PVNGS UNIT 1

**MARKED UP TECHNICAL SPECIFICATIONS
TO SUPPORT NRC GENERIC LETTER 88-16**

FIGURE 9
DNBR MARGIN OPERATING LIMIT BASED ON CORE PROTECTION CALCULATORS
(COLSS OUT OF SERVICE, CEACs OPERABLE)

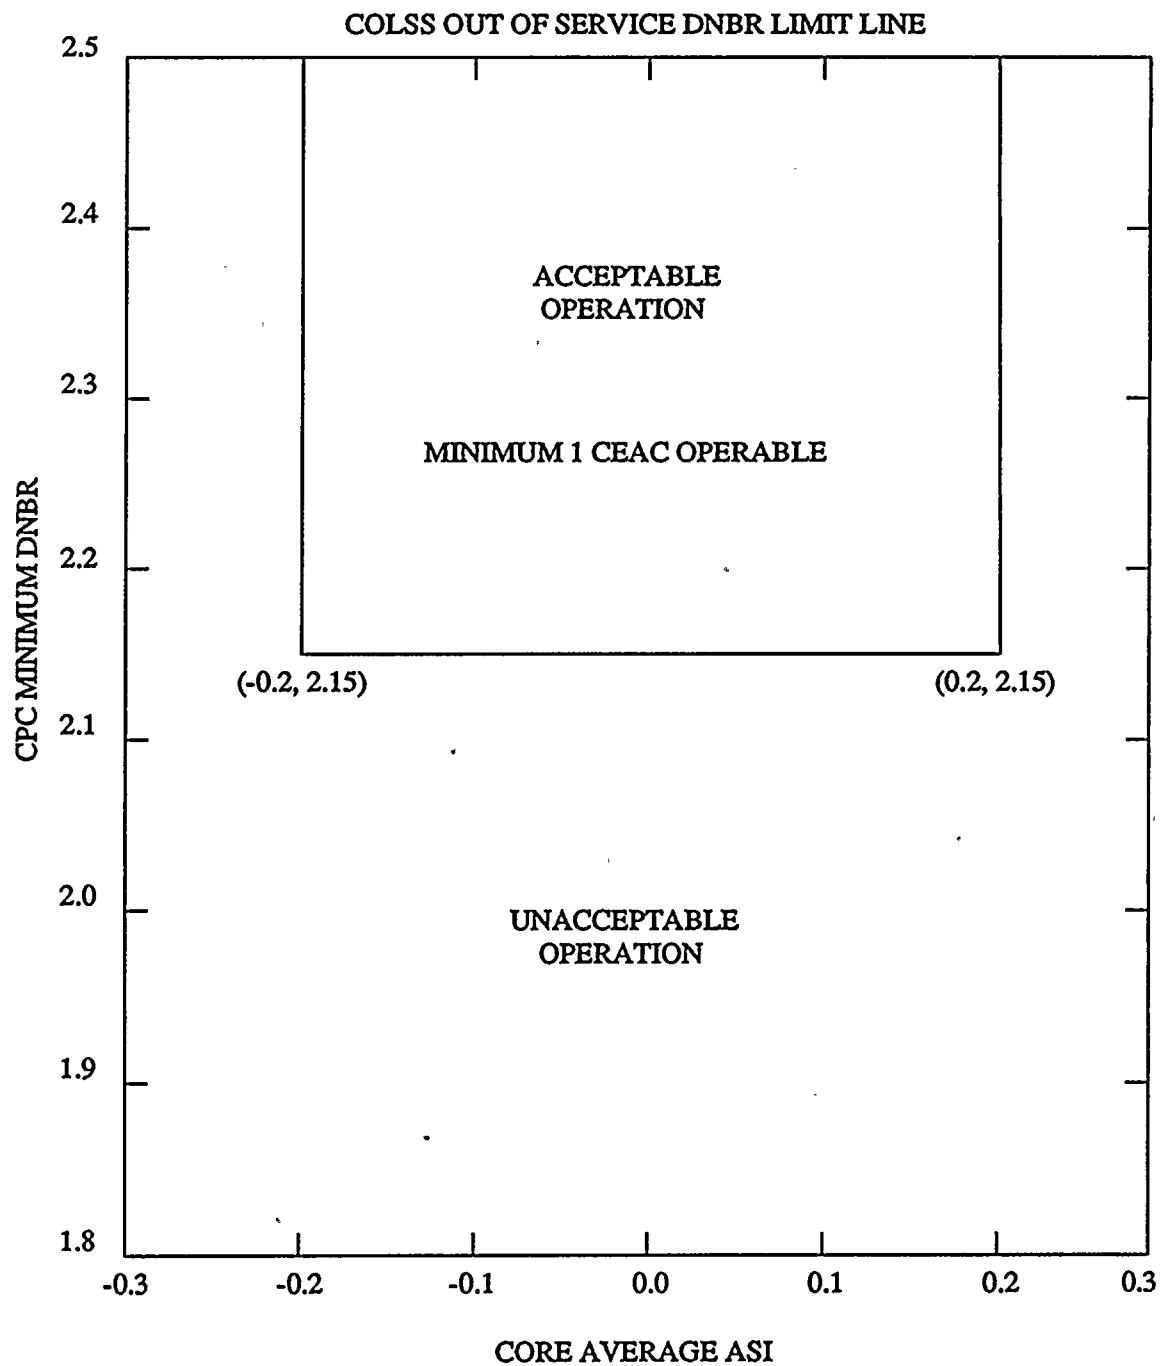
COLSS OUT OF SERVICE and Either One or Both CEAC's are OPERABLE - Operating within the region of acceptable operation of Figure 9 using any operable CPC channel.

FIGURE 10

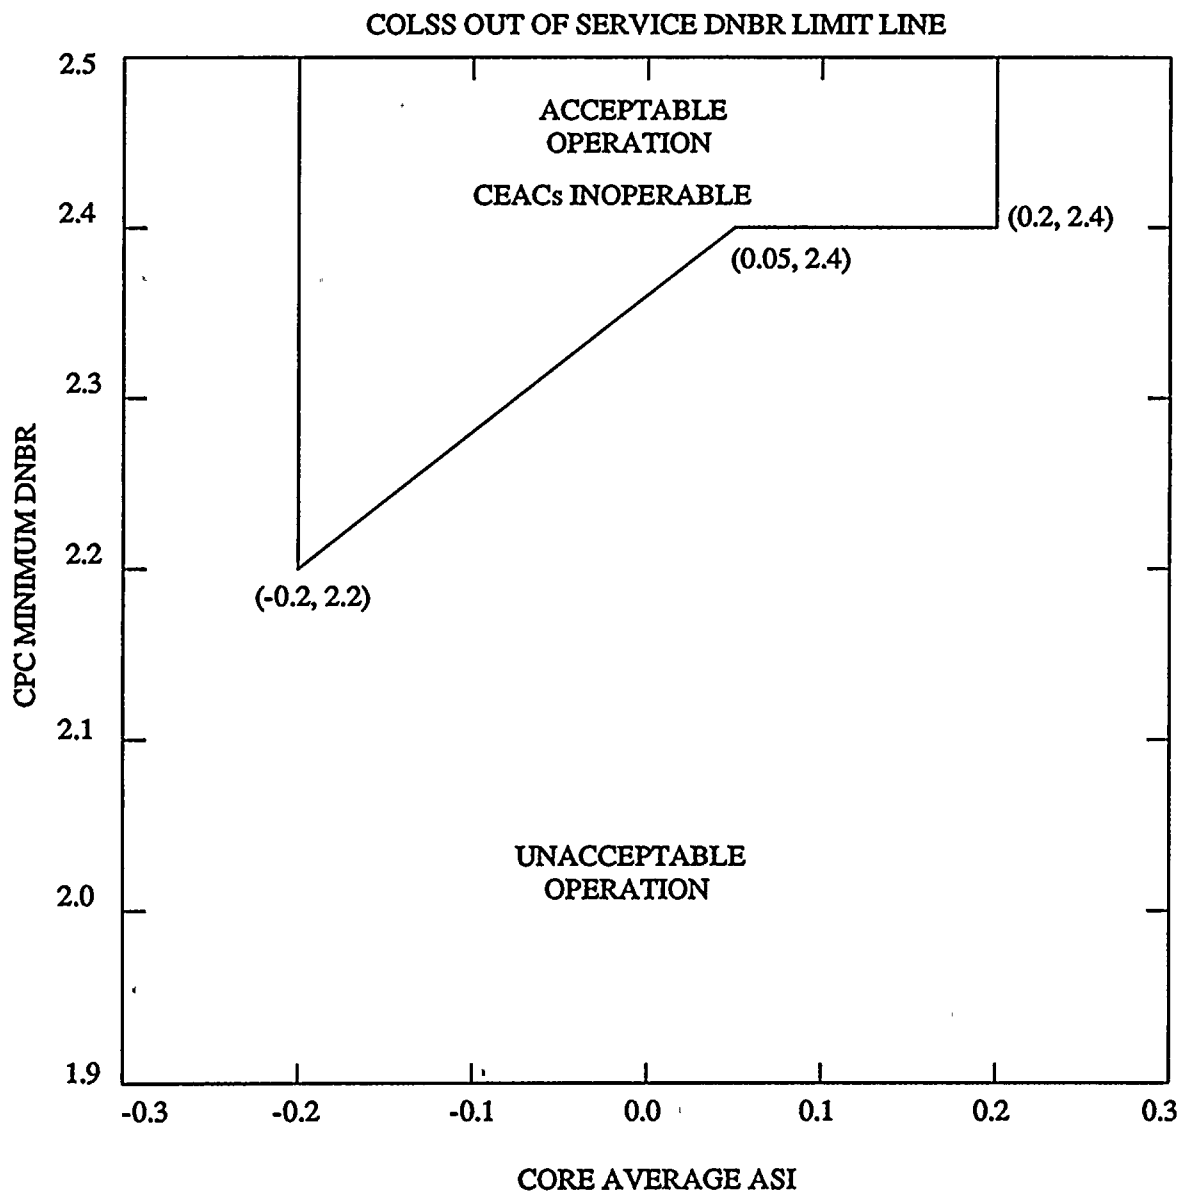
COLSS OUT OF SERVICE and CEAC's INOPERABLE - Operating within the region of acceptable operation of Figure 10 using any operable CPC channel.
